Proposal for the addition of a lateral facing carrycot icon to the module labelling options.

Format review of module label

Improved for 62nd IG

22 November 2016

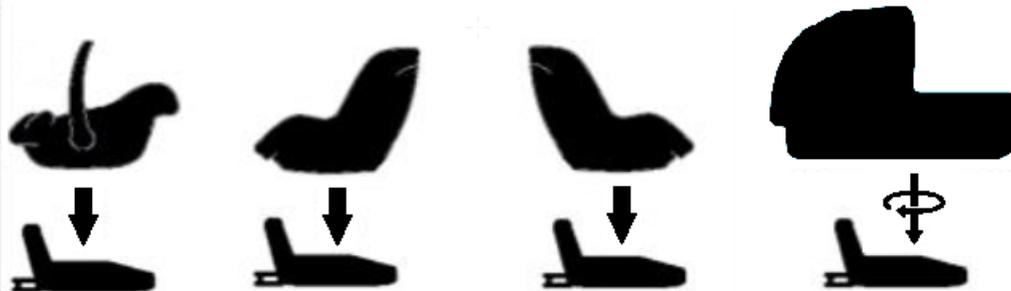
- In the 61st meeting a proposal to add a Lateral facing carrycot was presented.
- Different arrow requested for the lateral facing carrycot (Vti, ANEC; @ 61st meeting)
- New suggestion:

By choice of the ECRS manufacturer, one or more of the following symbols must be used on the module label

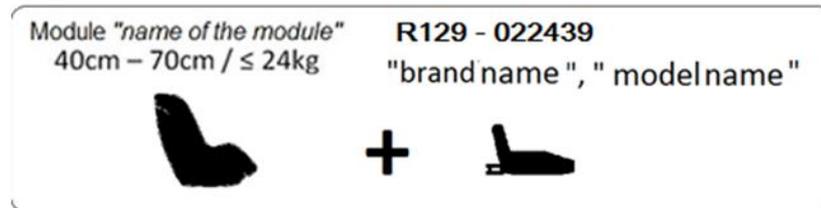
- However there is also a dilemma. This is the current module label.

It however it can't be made by using just one of the icons provided.

- The icons to choose from are actually different then the one above.
- There is no '+' icon provided to choose from
- and the orientation is different compared to 'normal portrait layout'.

We like to suggest a different module label layout

## Icons to choose from

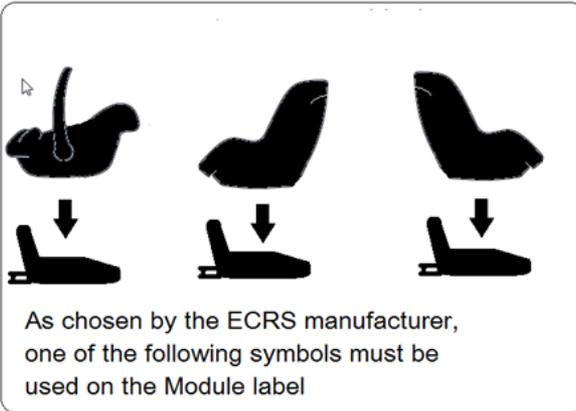
# New proposal

By choice of the ECRS manufacturer, one or more of the  
following symbols must be used on the module label
